TOWNHOUSES BUILDING D

CLARENDON HILL PHASE TWO POAH

ZONING SUBMISSION 06/15/2026 REV 07/22/2026

ZONING DIMENSIONAL STANDARDS TABLE

Z-002

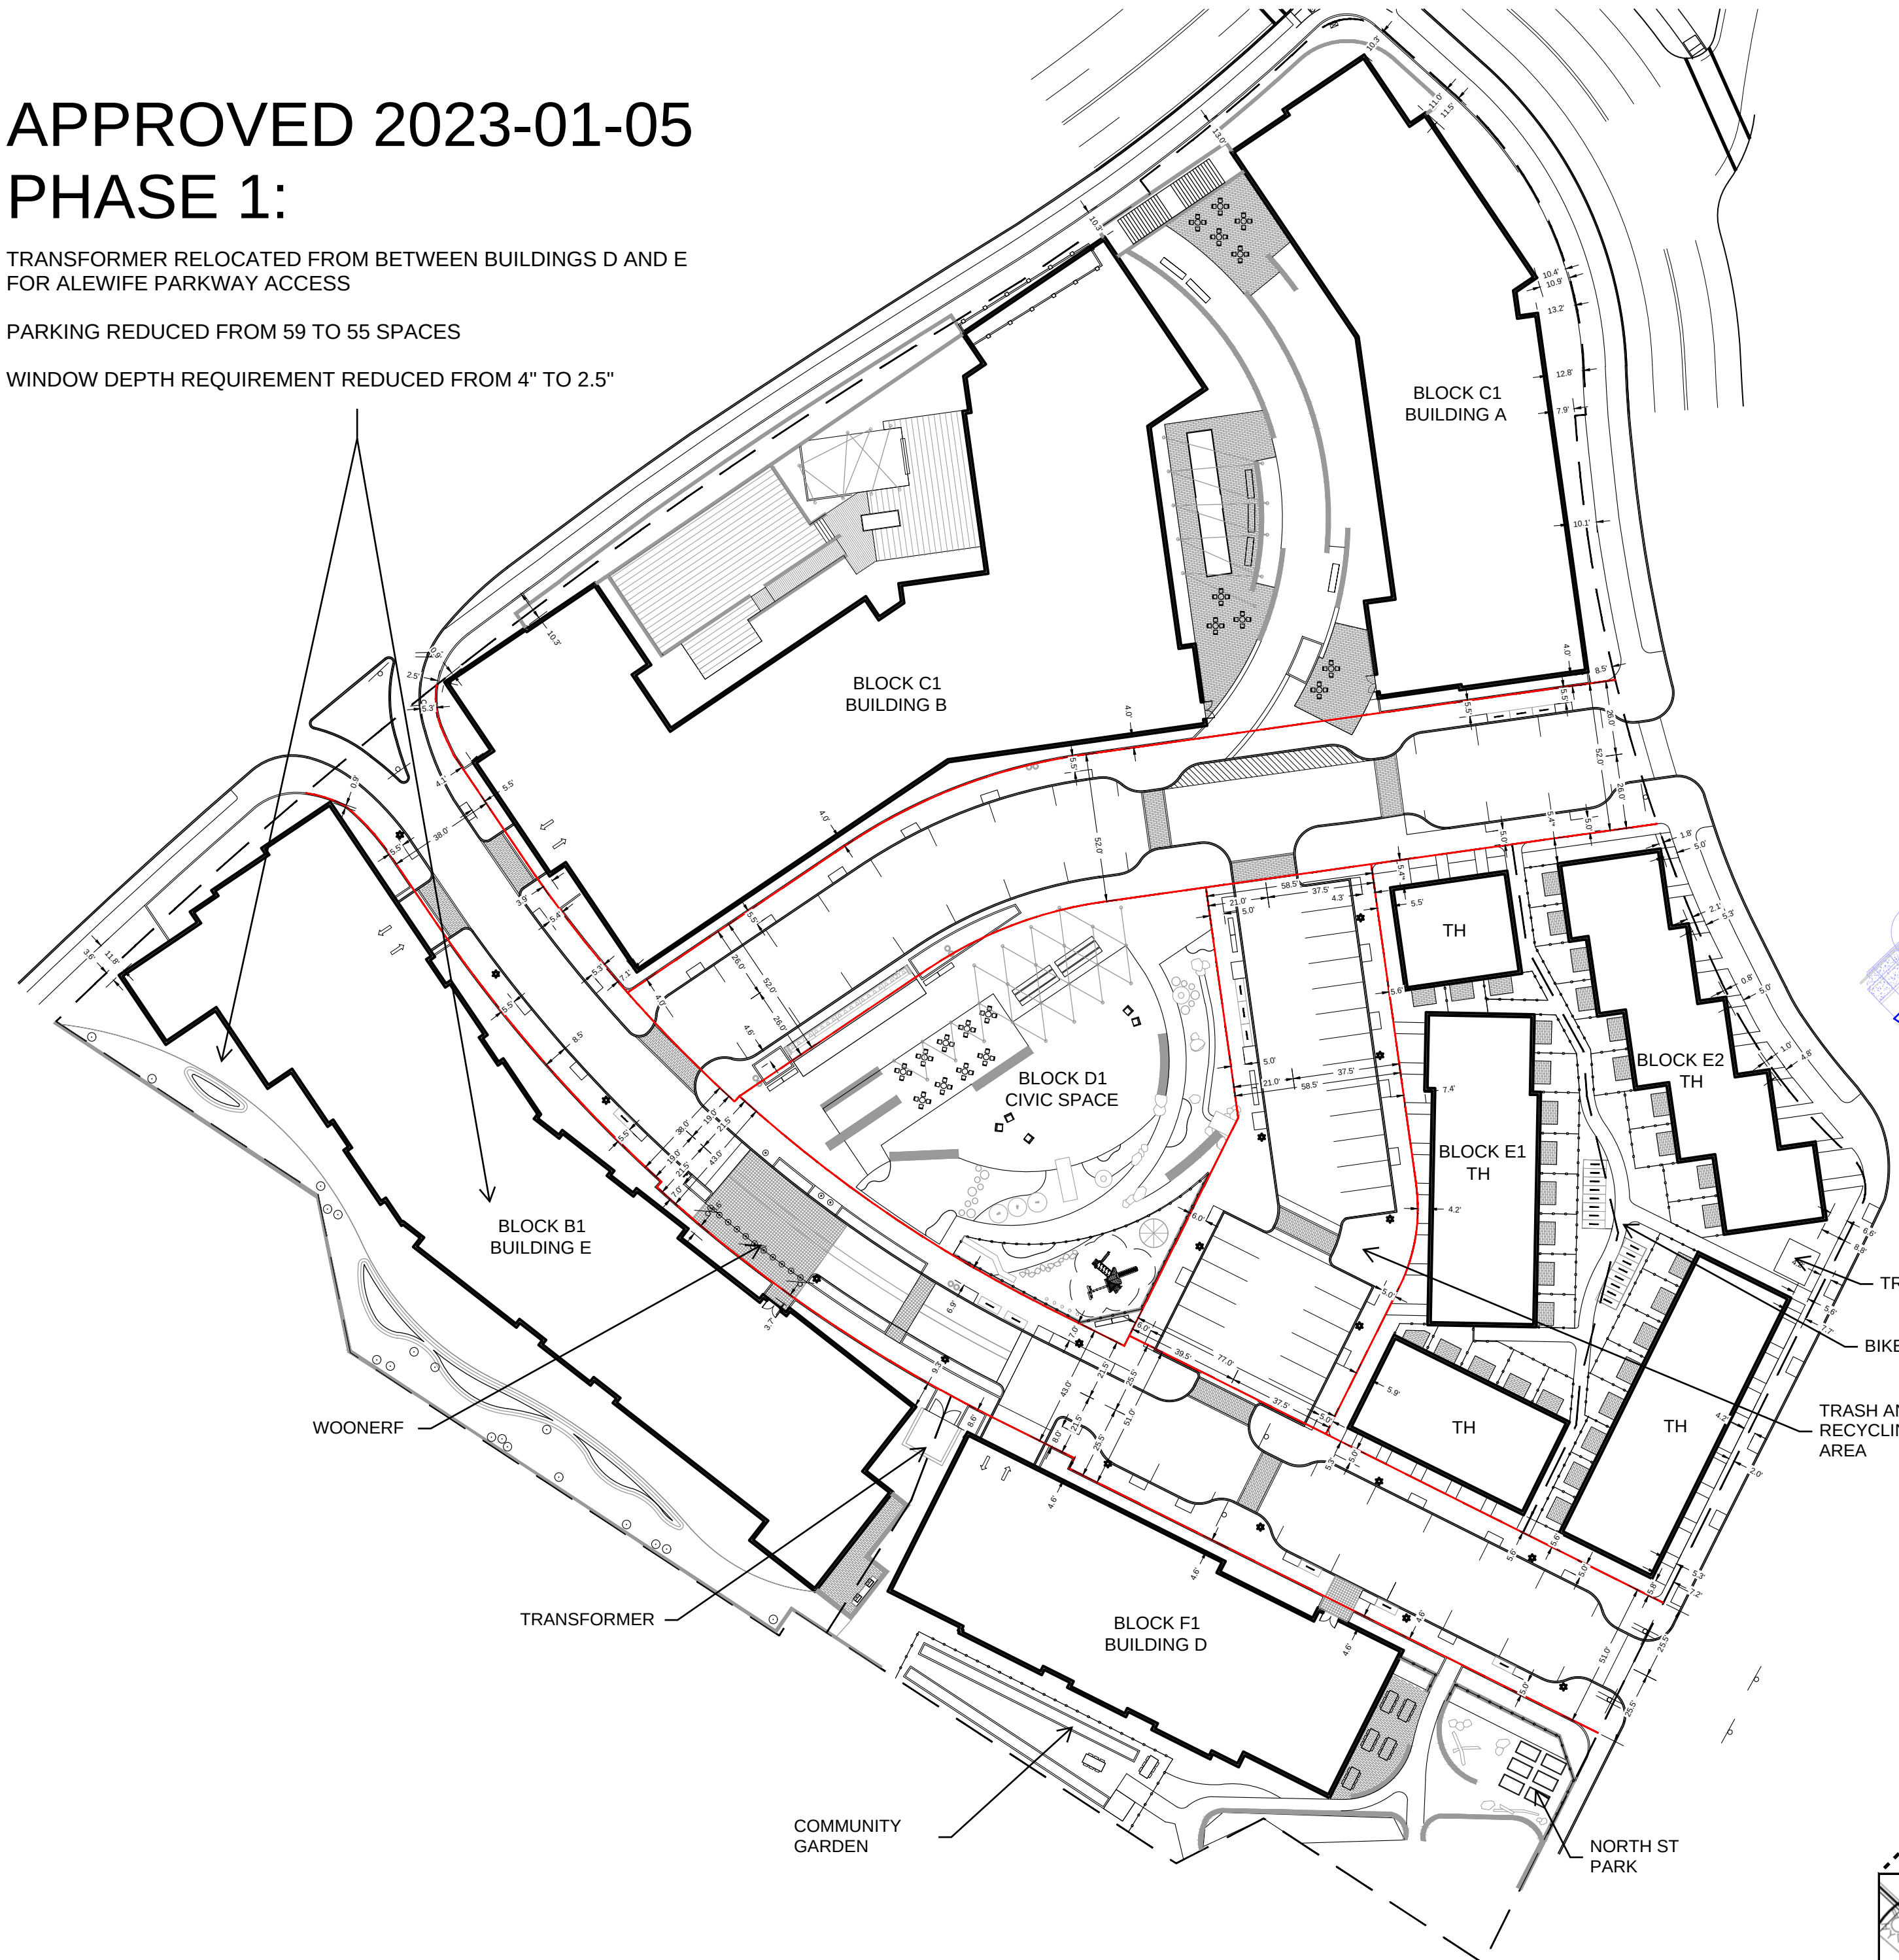
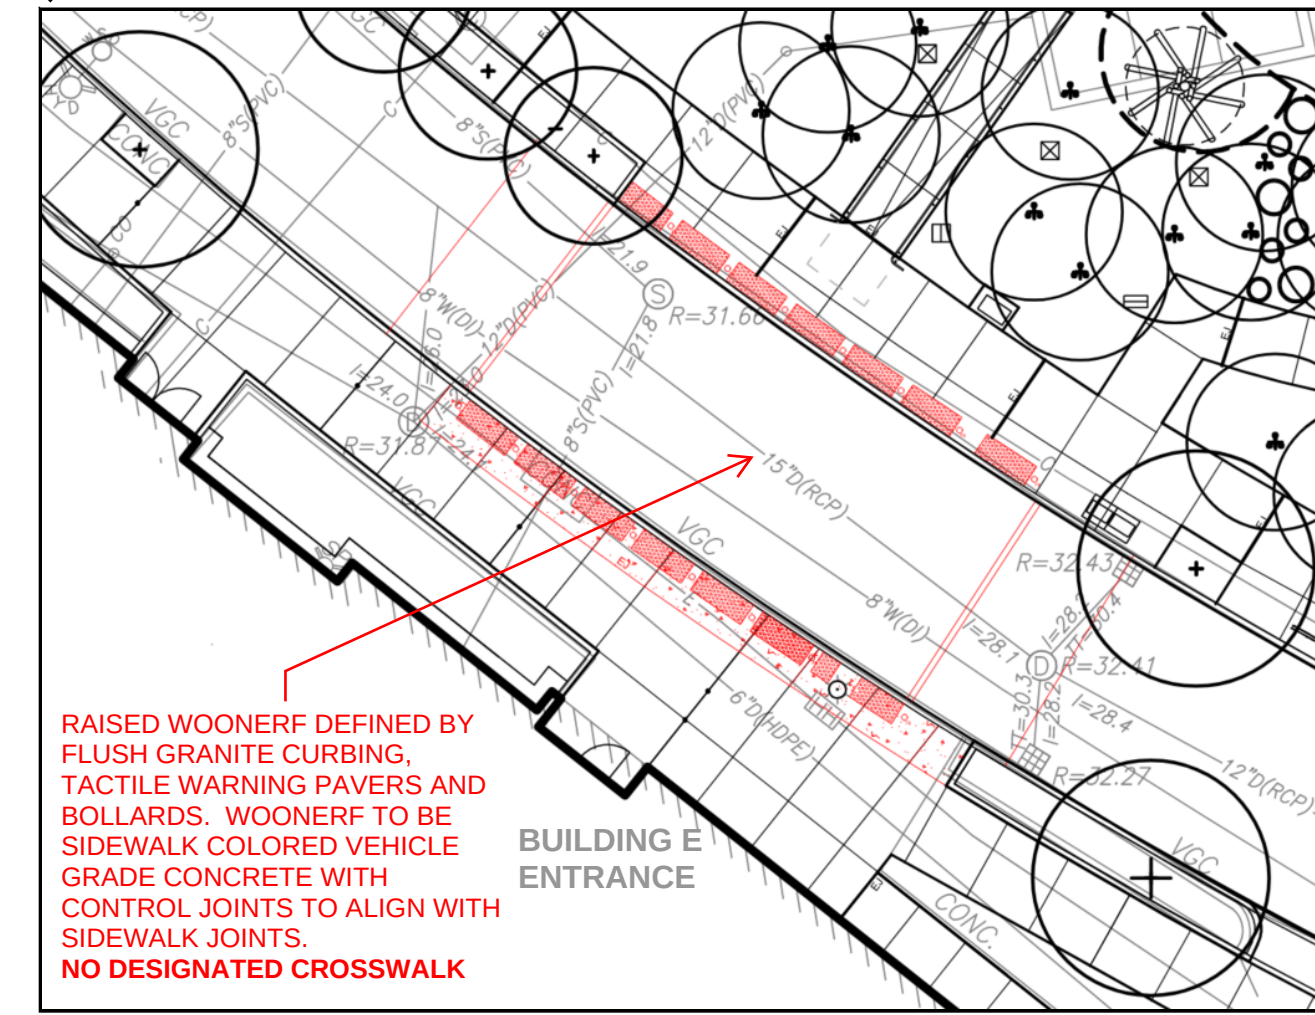
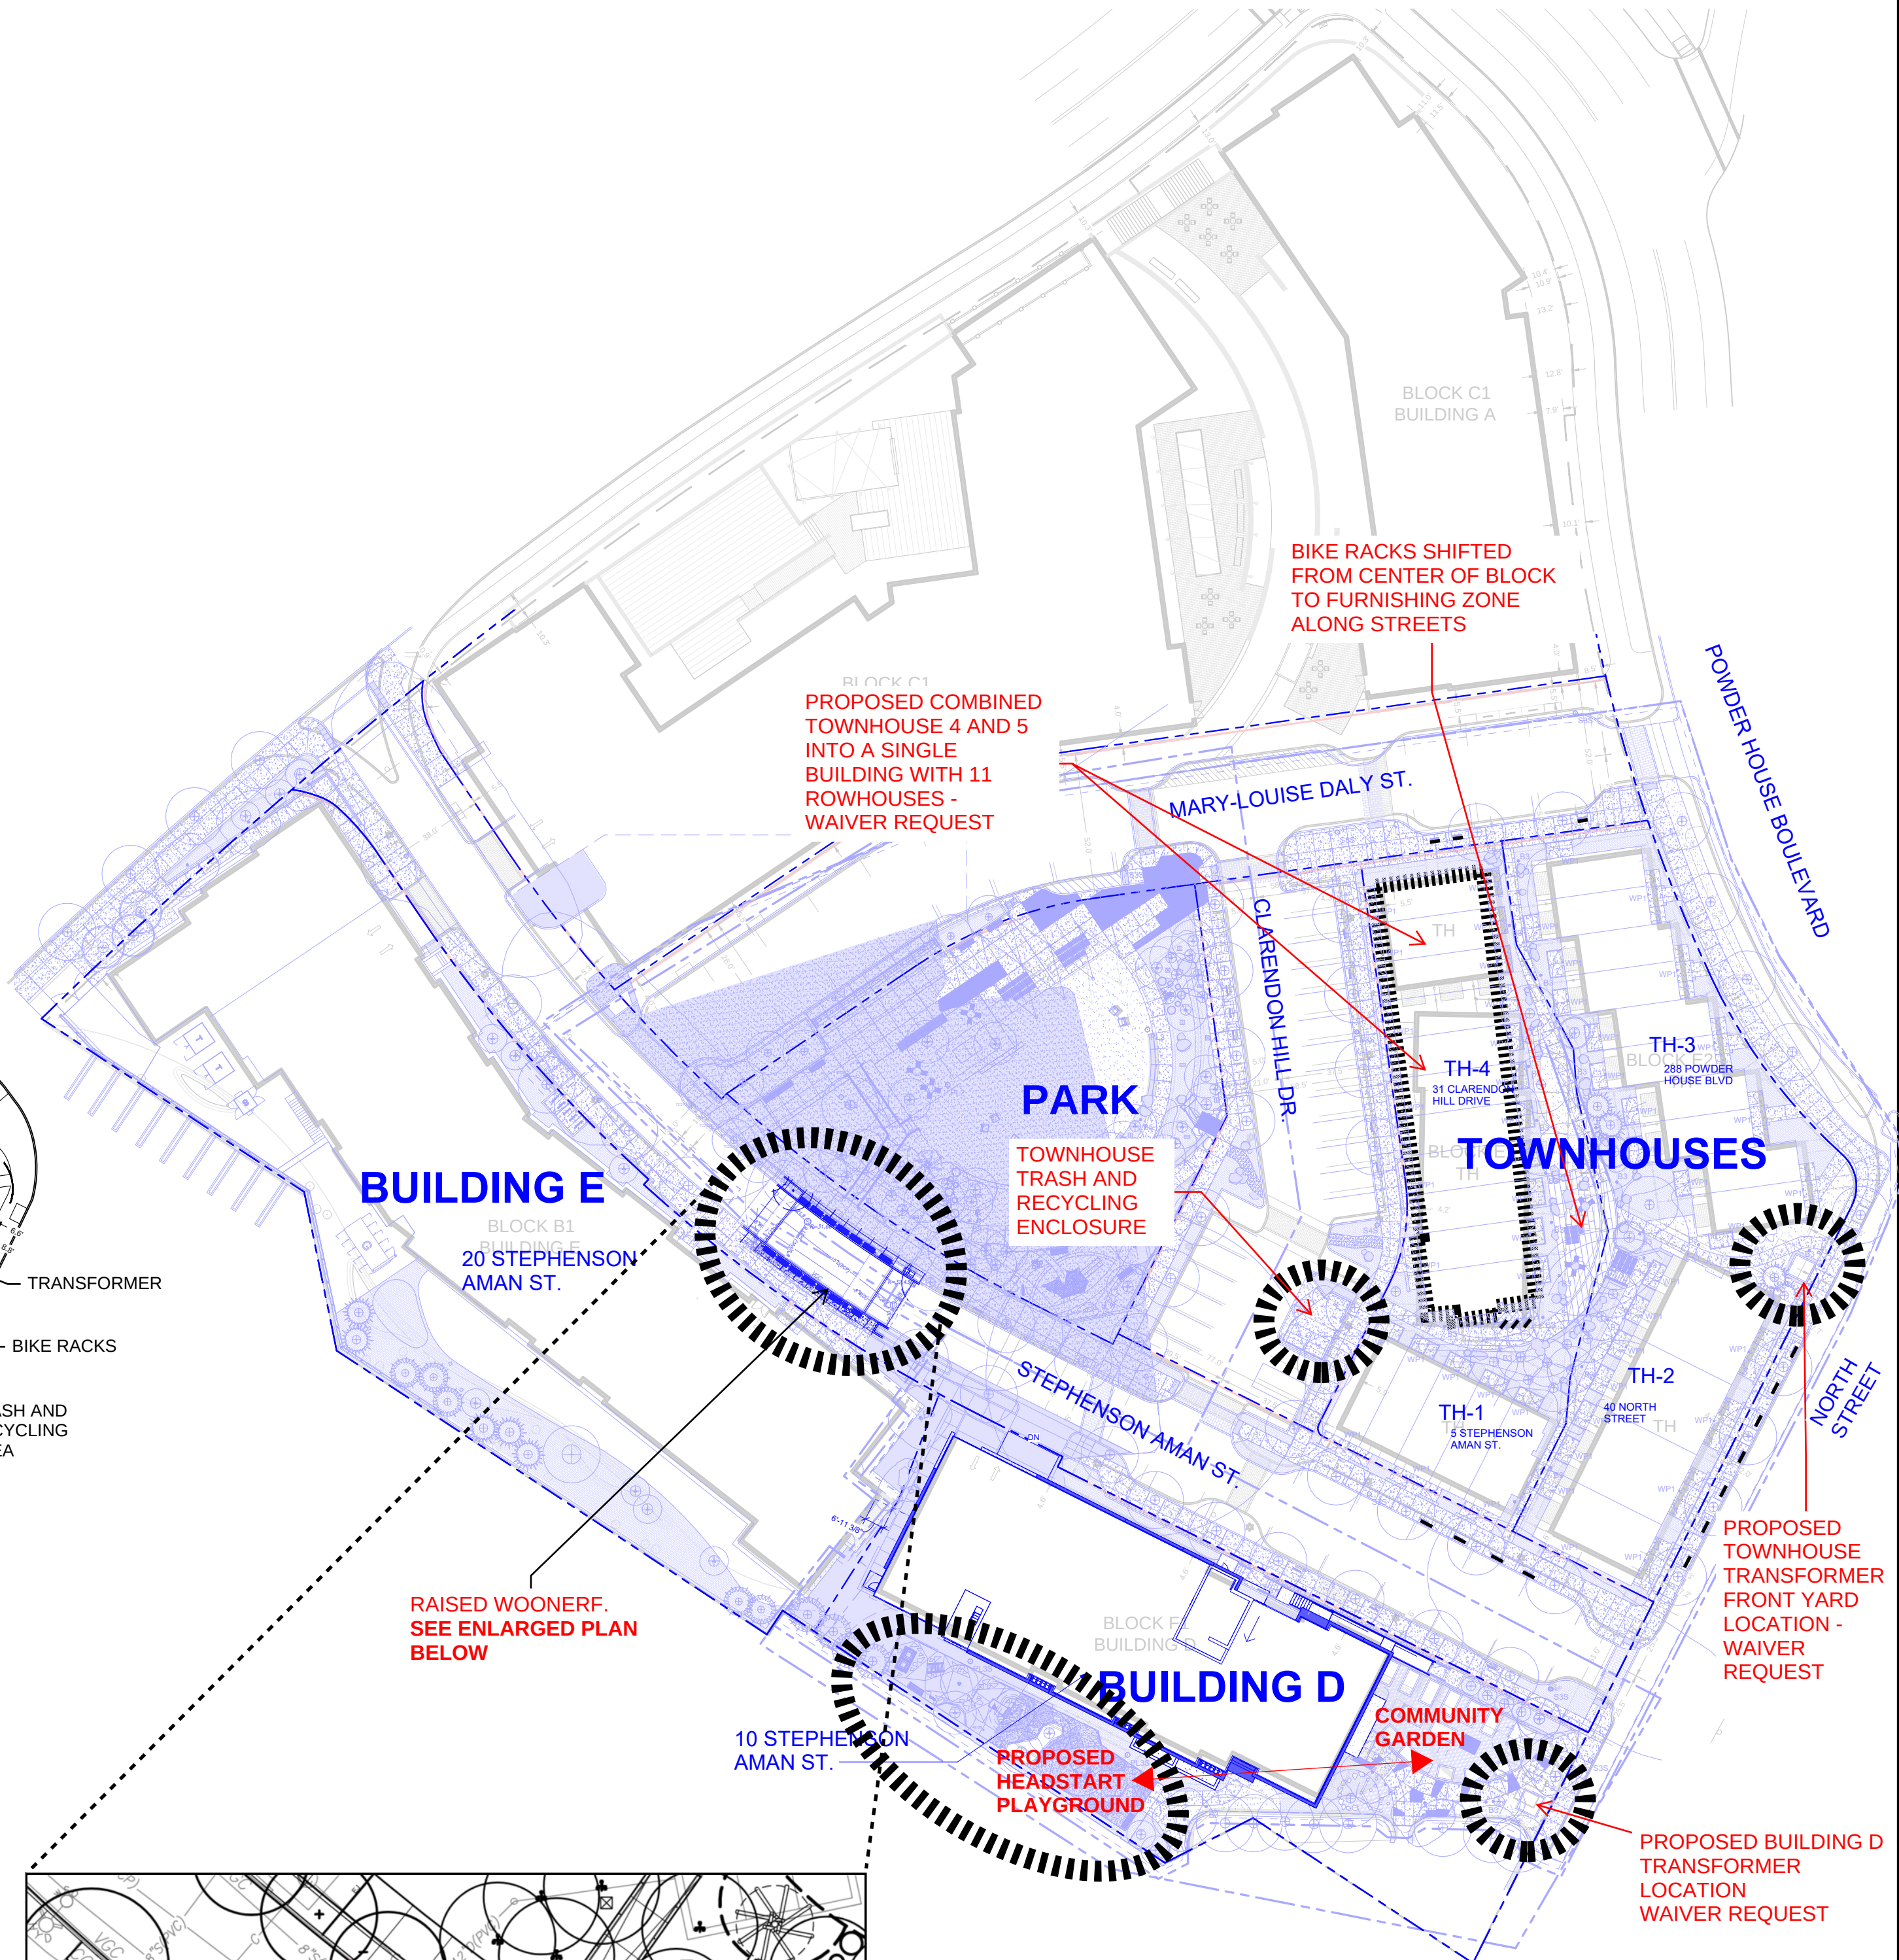
TRANSFORMER RELOCATED FROM BETWEEN BUILDINGS D AND E
FOR ALEWIFE PARKWAY ACCESS
PARKING REDUCED FROM 59 TO 55 SPACES
WINDOW DEPTH REQUIREMENT REDUCED FROM 4" TO 2.5"

PROPOSED ENLARGED WOONERF

PROPOSED JUNE 15, 2026
SITE LAYOUT: PHASE 2
